Addendum 4

Date: 10/28/22

Addendum 4 Items:

A1 LEVEL 1A FLOOR PLAN
A101a SCALE: 1/8" = 1'-0"

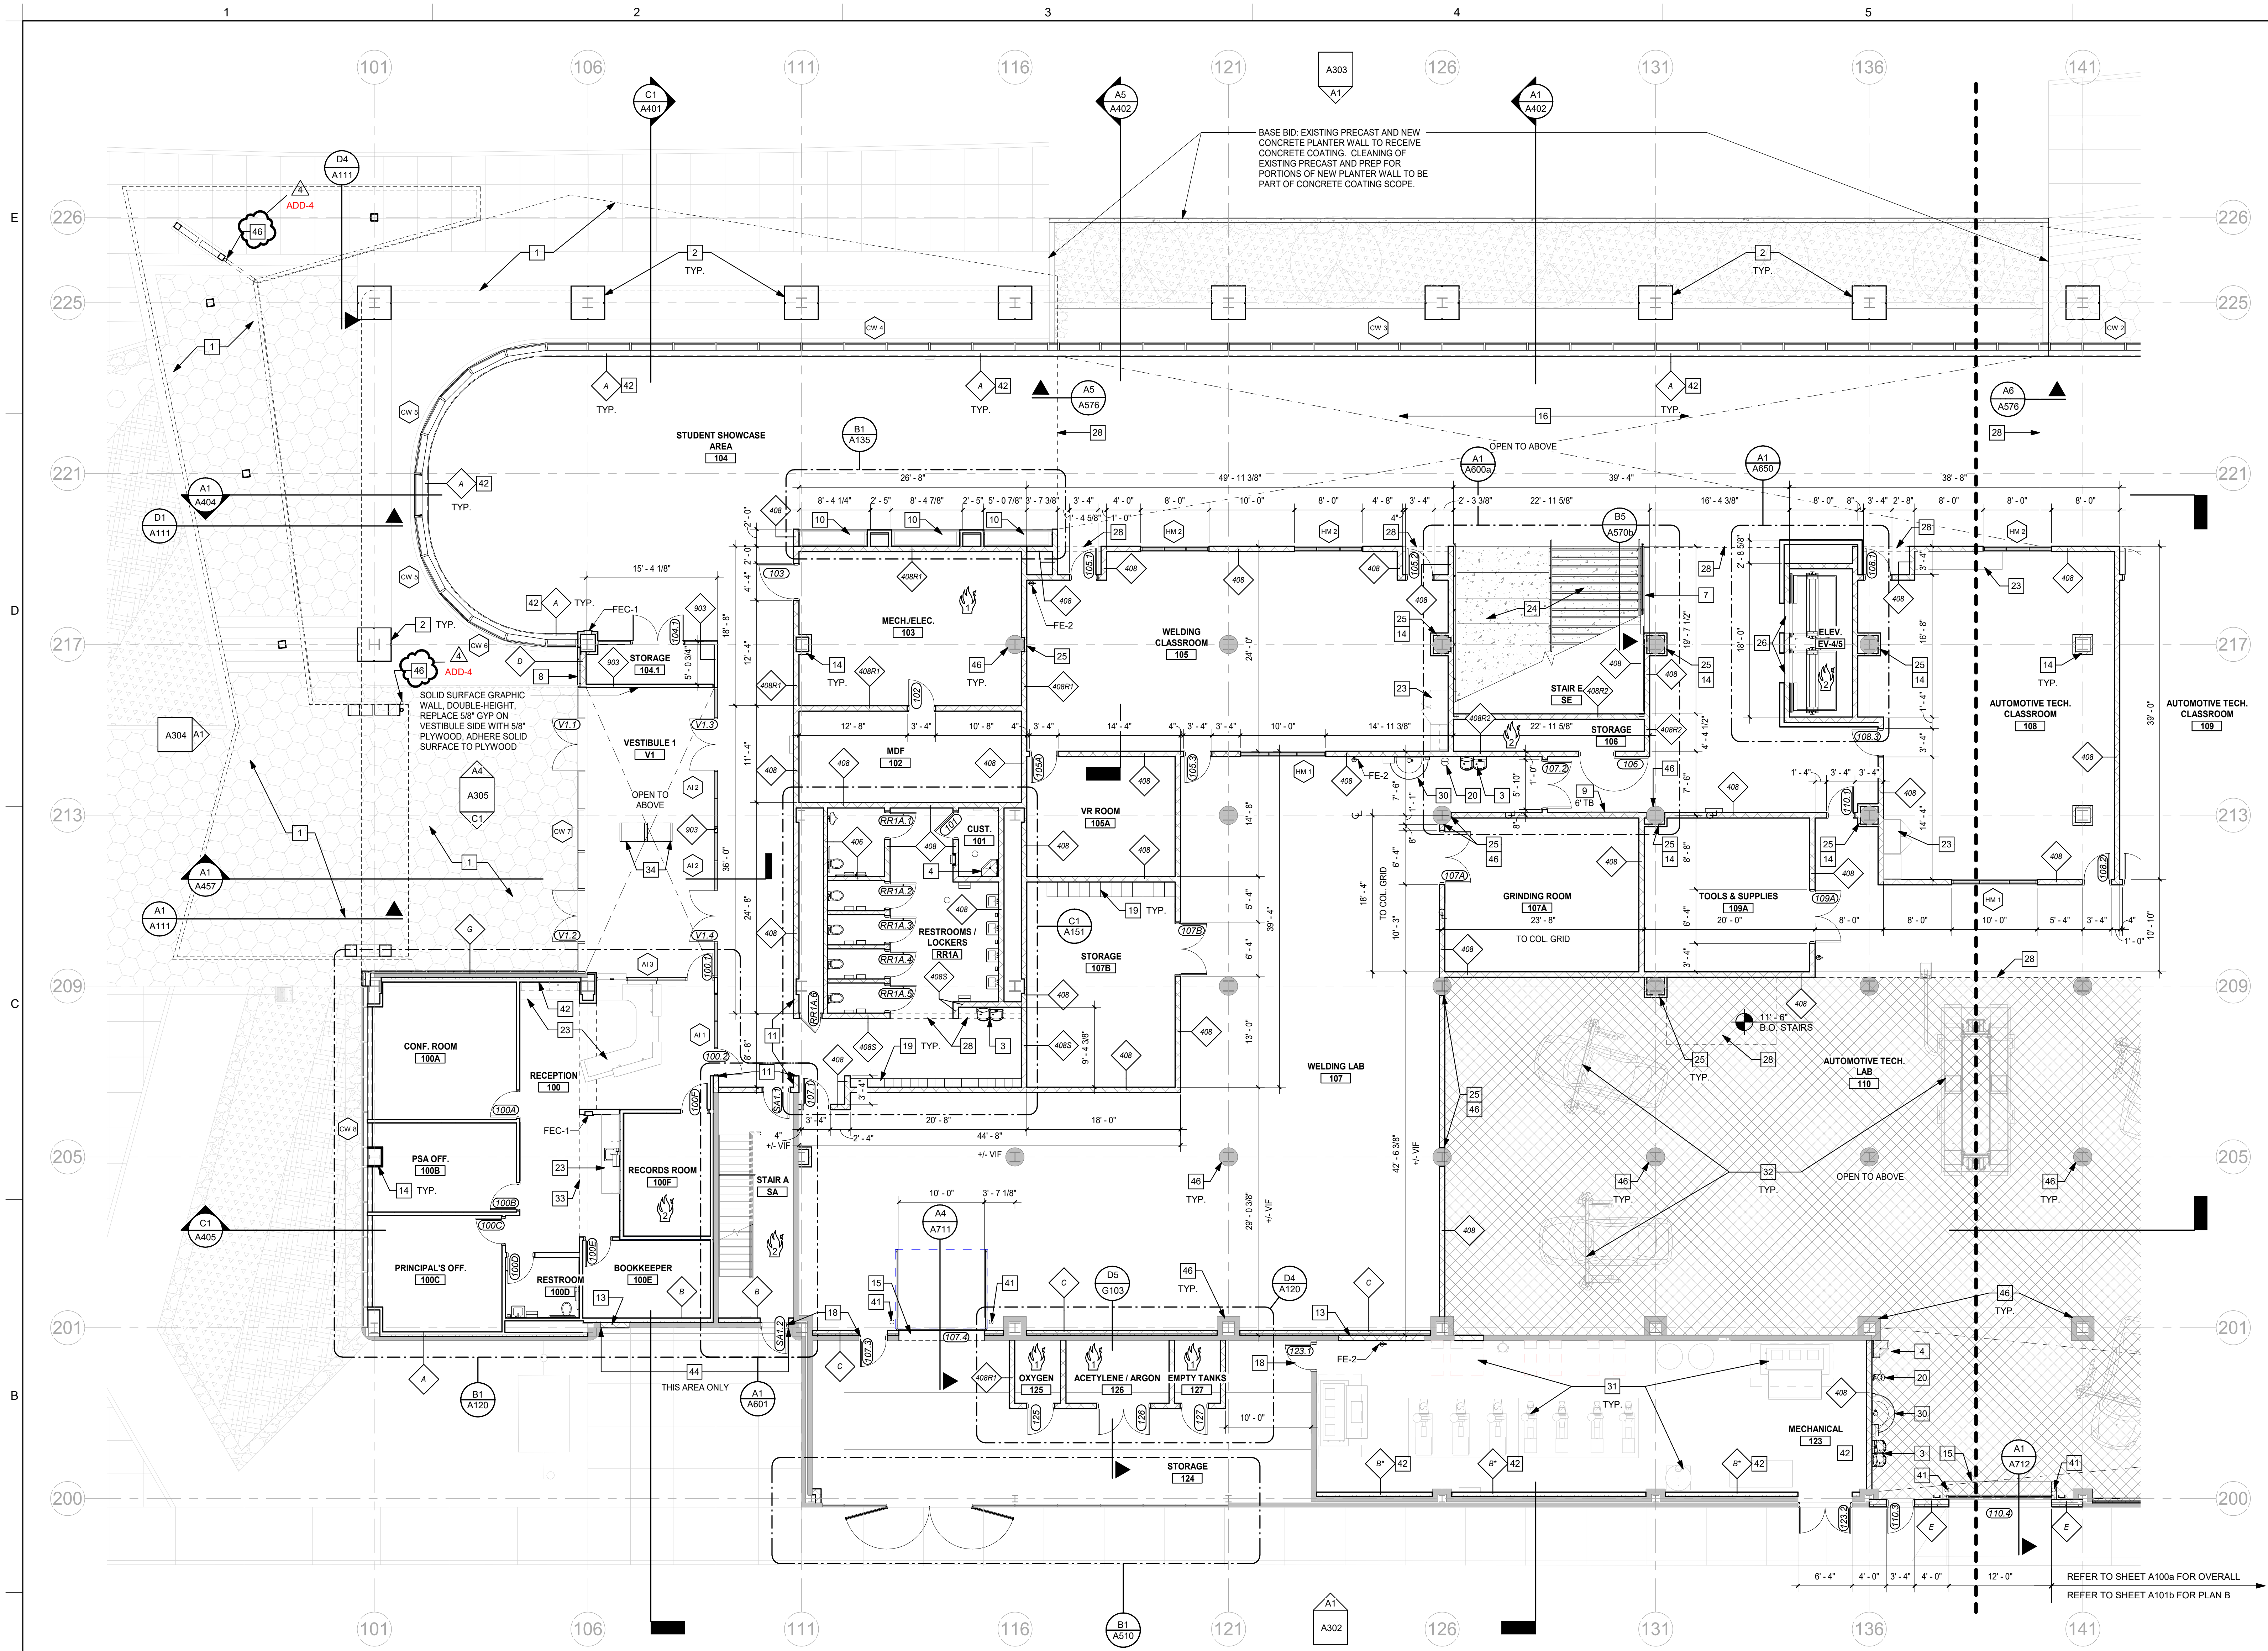
Refer to sheets A101A and A101B for revisions to the canopies and added downspouts and rain chain.

M408

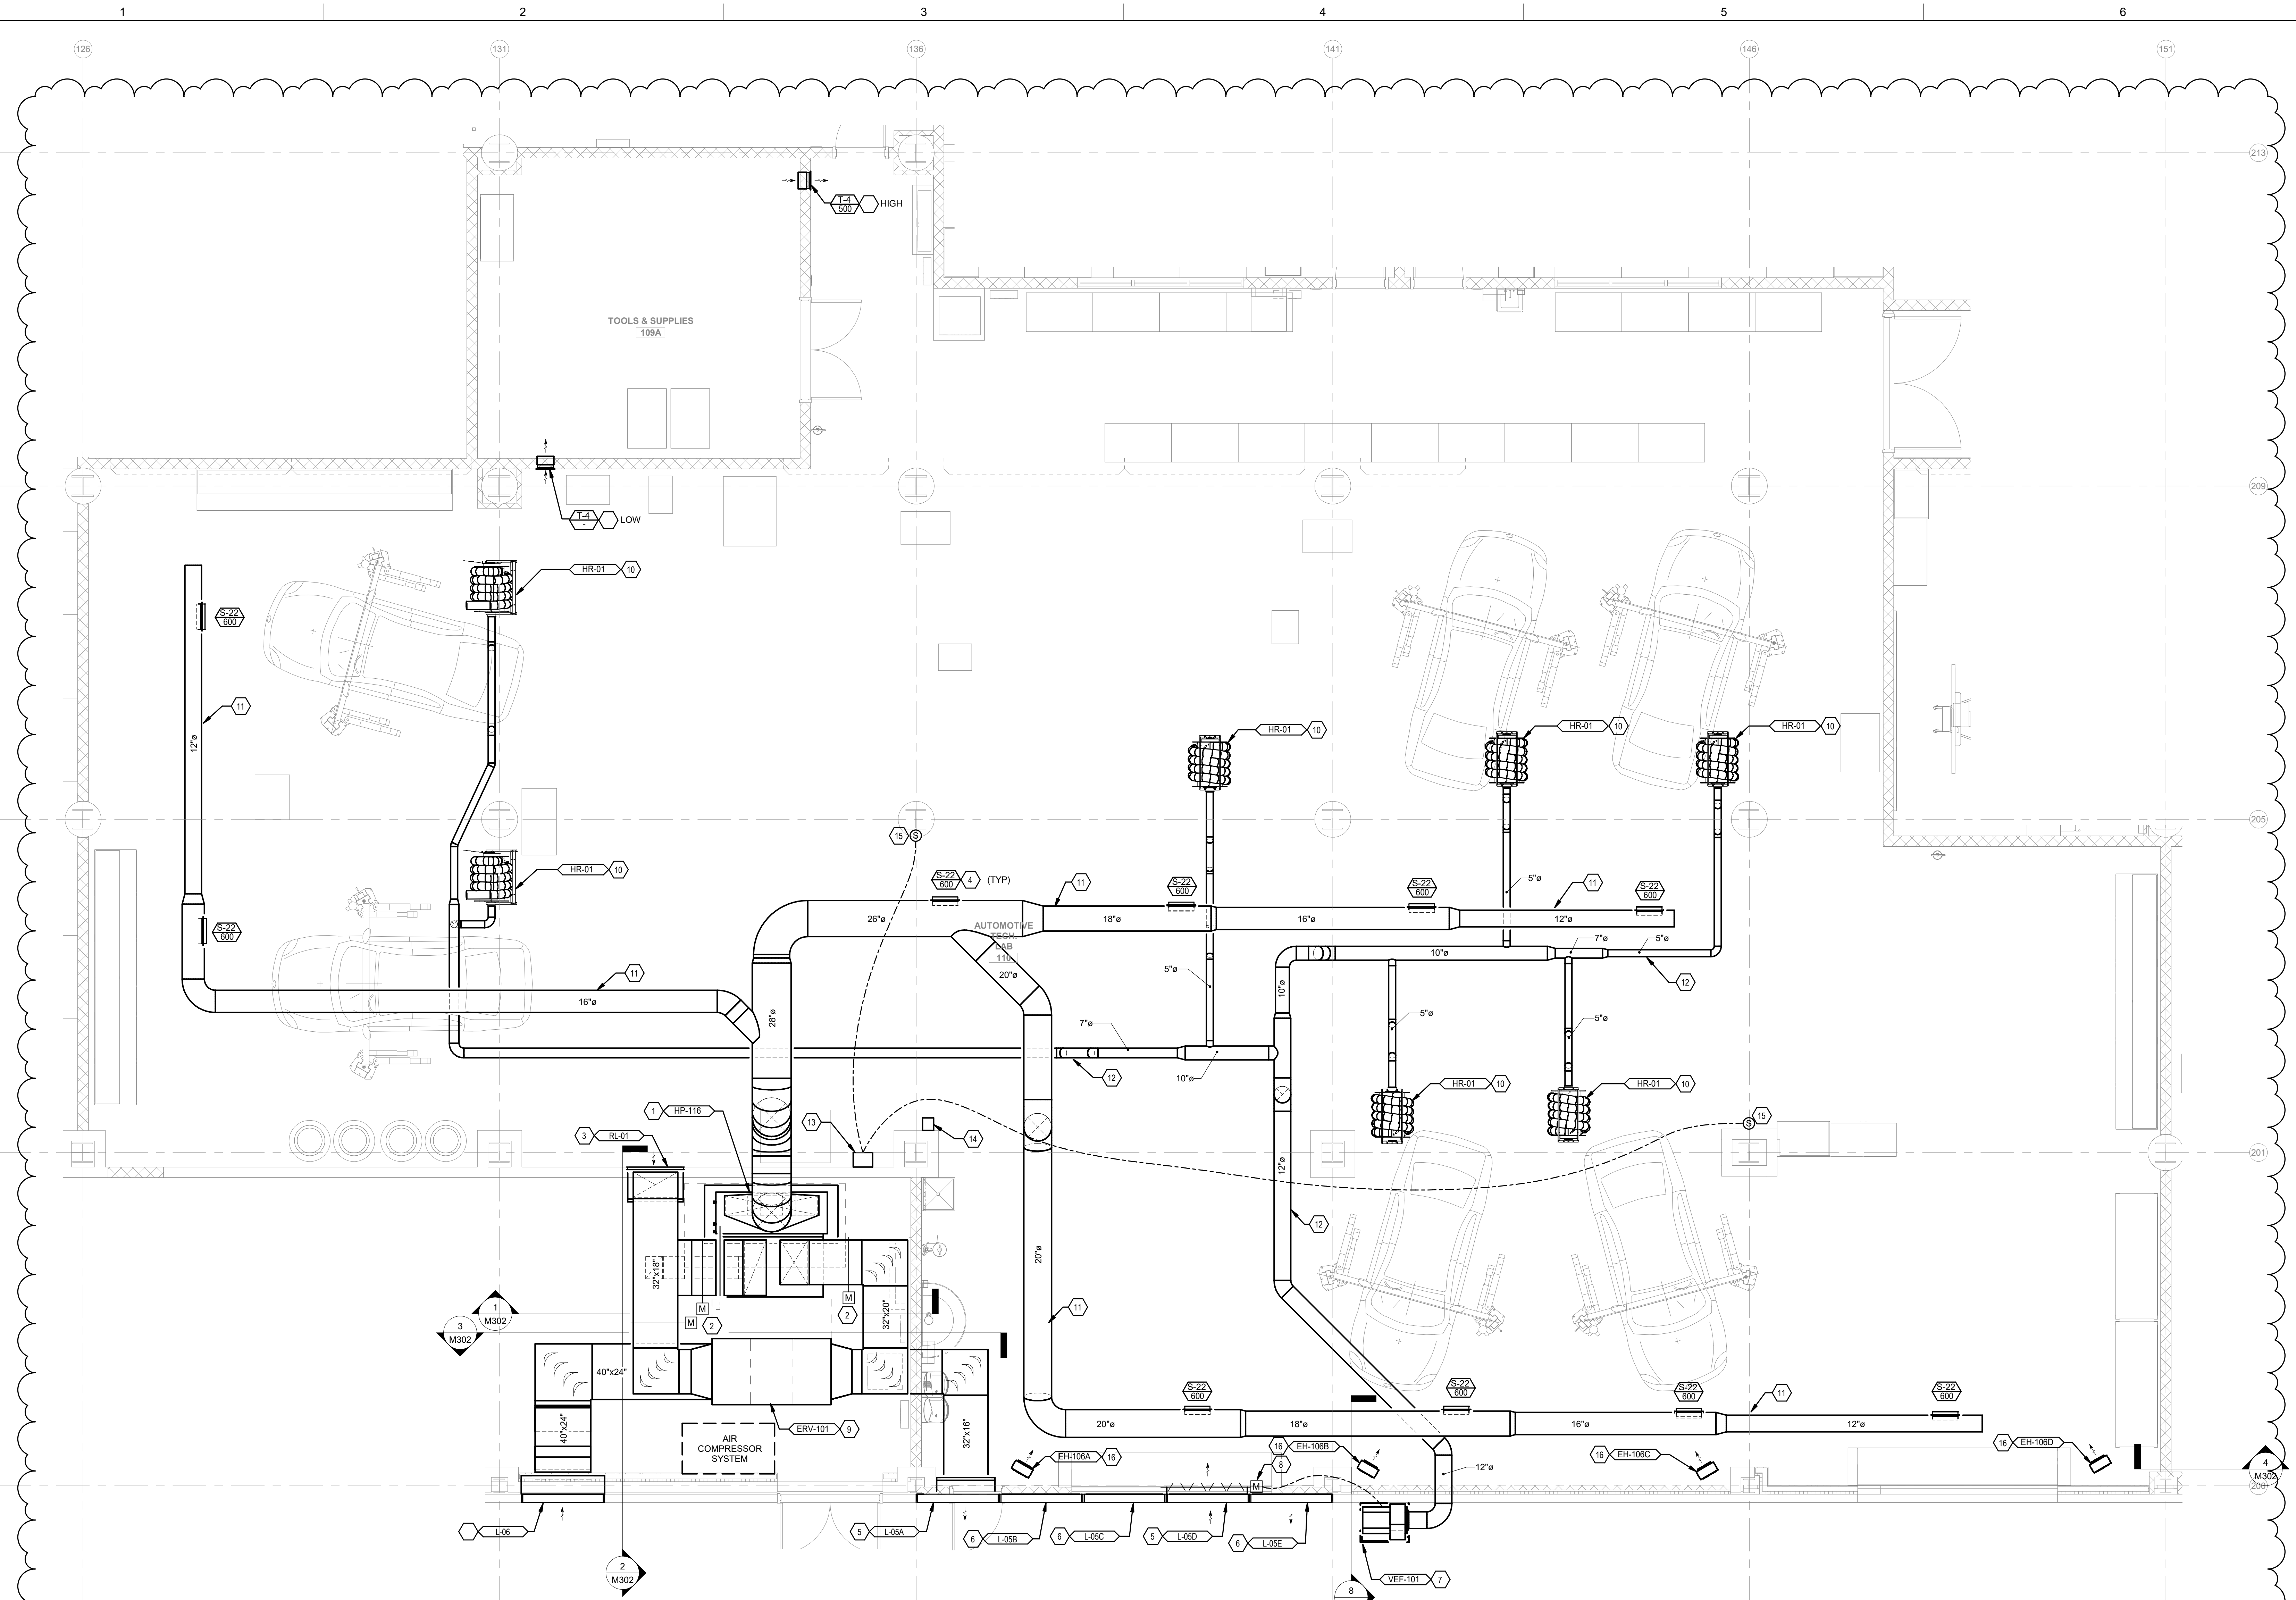
- DIRECT OUTSIDE AIR VENTILATION - sequence shall be deleted in its entirety.
- AUTOMOTIVE / DIESEL ENGIN GAS DETECTION SYSTEMS – revise as follows:
 - The system has been modified per drawings M407 and M408. Primary / Secondary Exhaust Fans have been deleted and replaced with an Air to Air Energy Recovery Ventilator. (ERV-101 & ERV-102)
 - ERV for each space shall run continuously during occupied hours and will be off during unoccupied hours.
 - Gas detection system will be used to monitor levels and provide alarms.
 - Gas detection system will be used to initialize HP Fan and ERV fan during unoccupied hours if the CO or NO2 levels exceed safe limits.
 - The following Points shall be monitored from ERV
 - O/A Entering Air Temp / Humidity
 - Supply to HP Discharge Air Temp / Humidity
 - Return to ERV Temp / Humidity
 - Supply and Exhaust Fan Command and Status
 - General Fault Alarms

S2.2

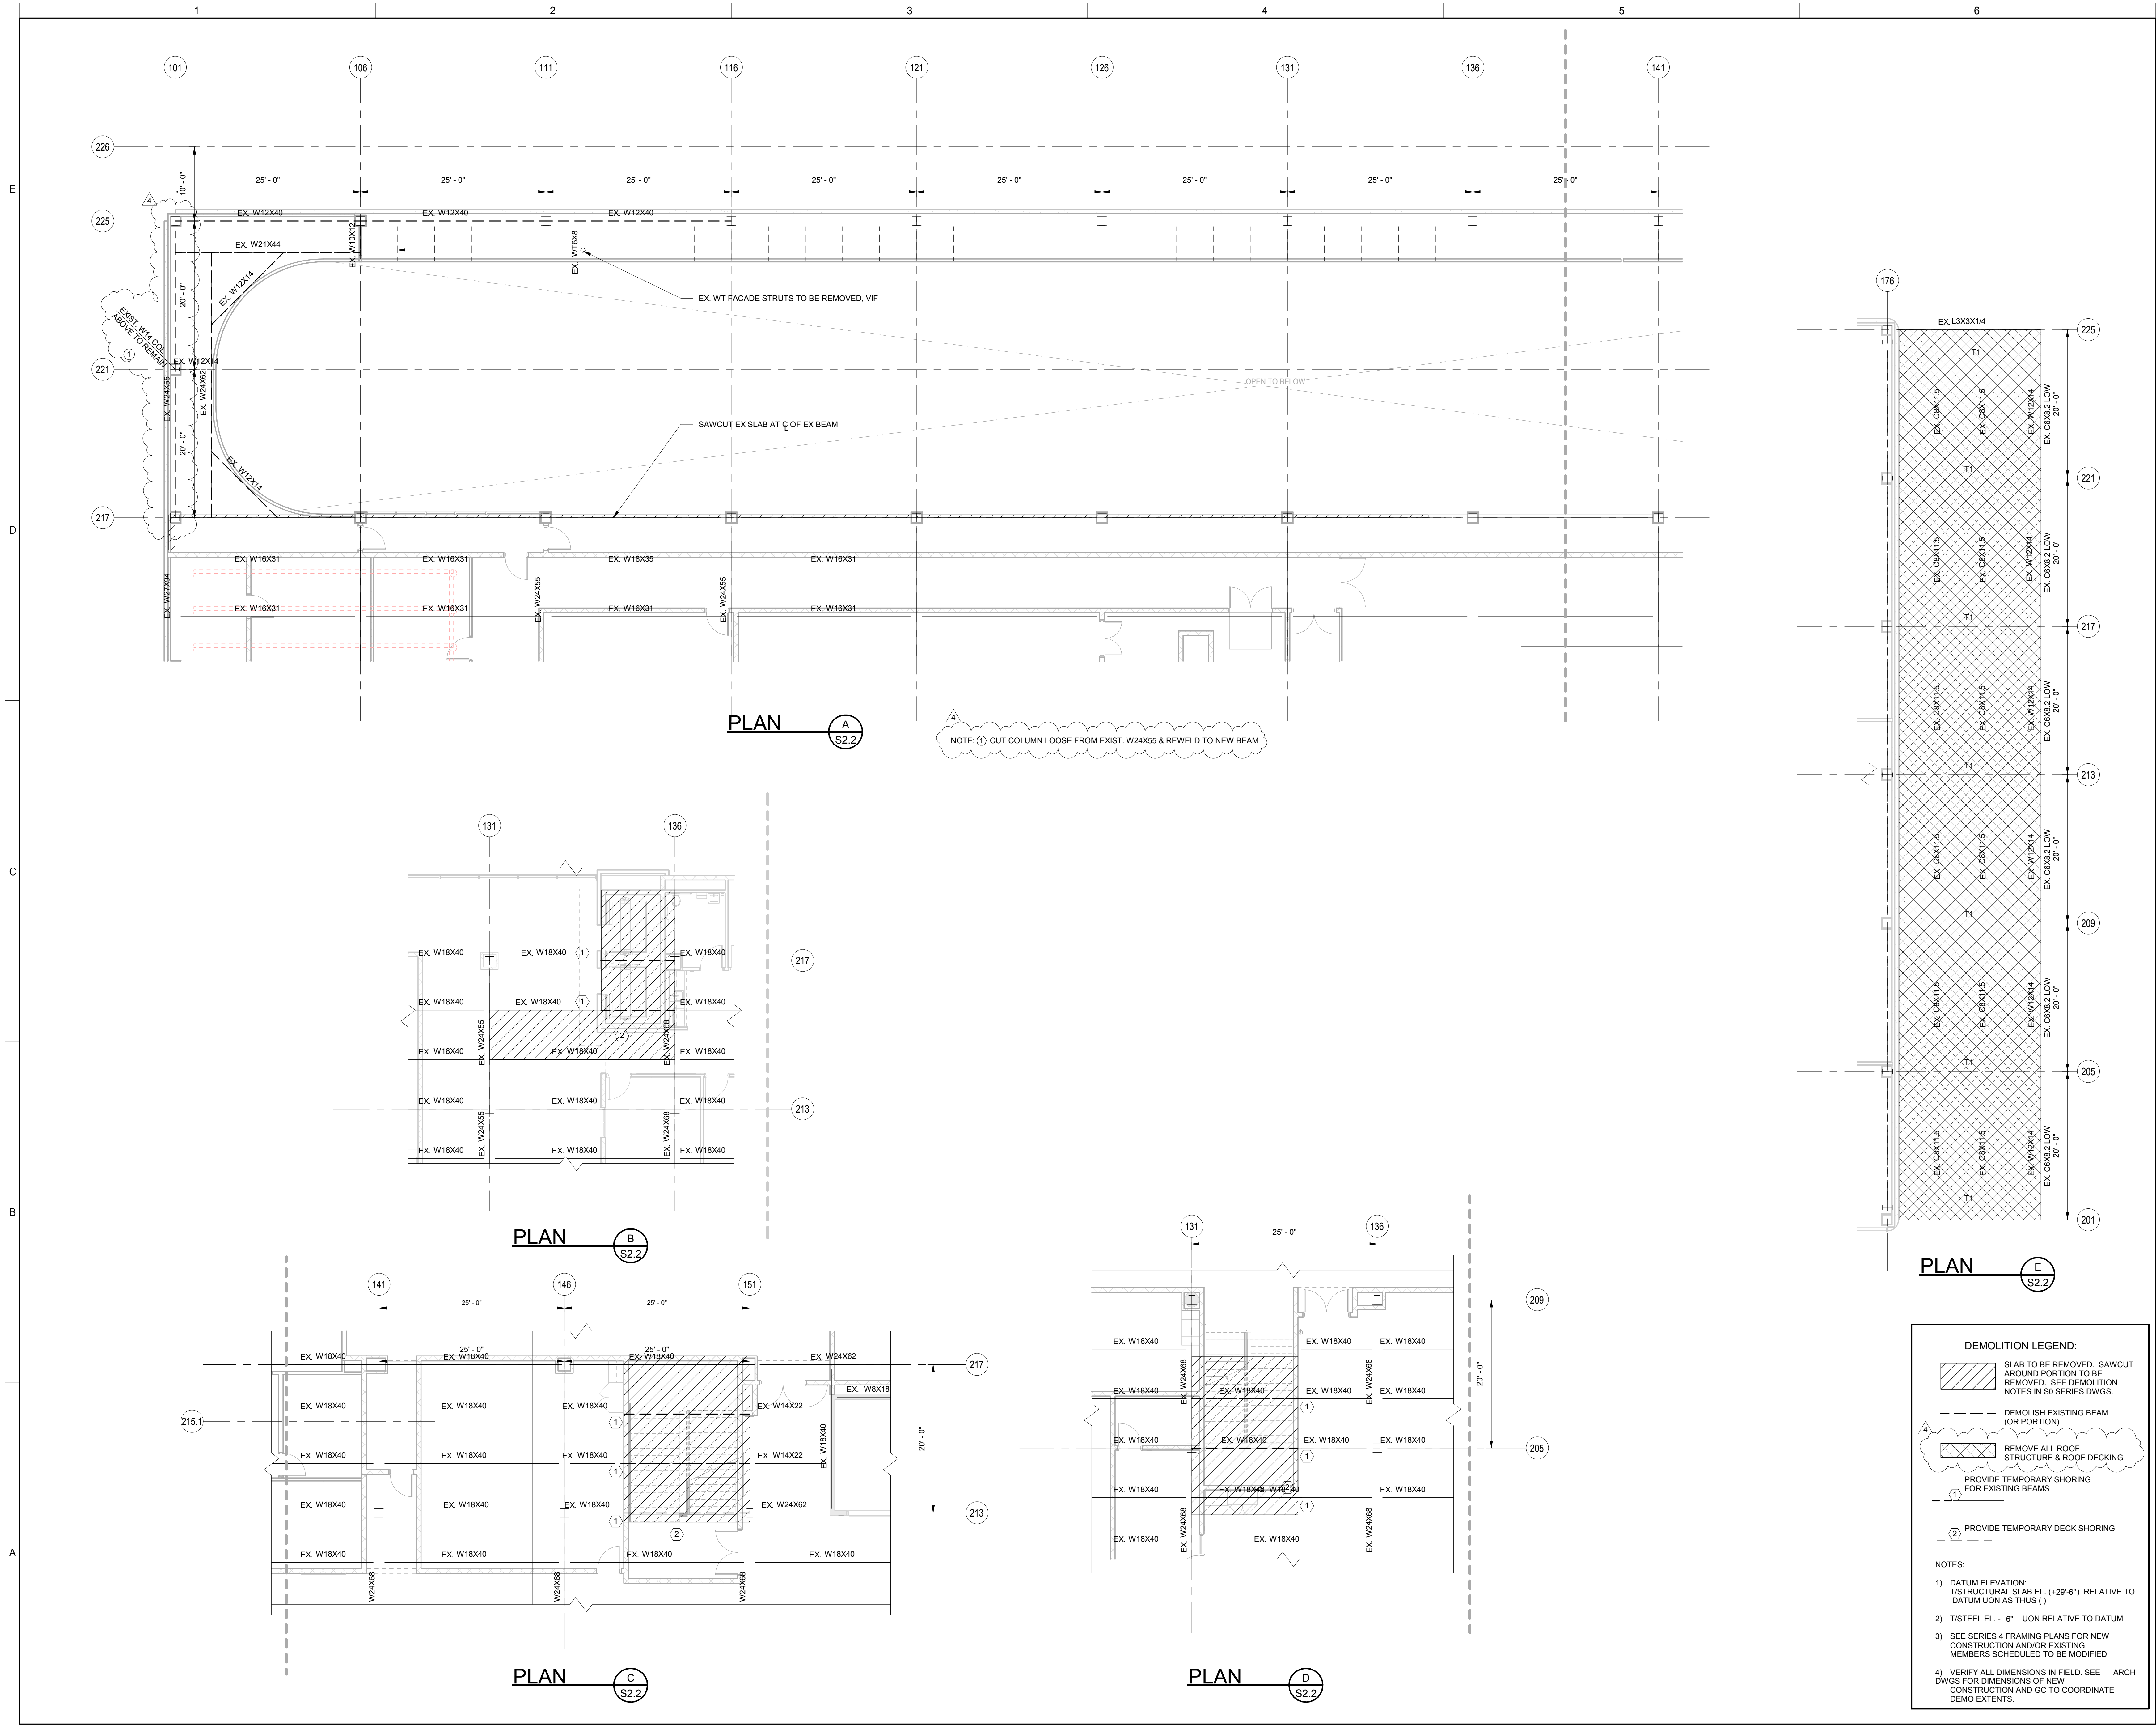
Refer to sheet S2.2
See clouded added notes
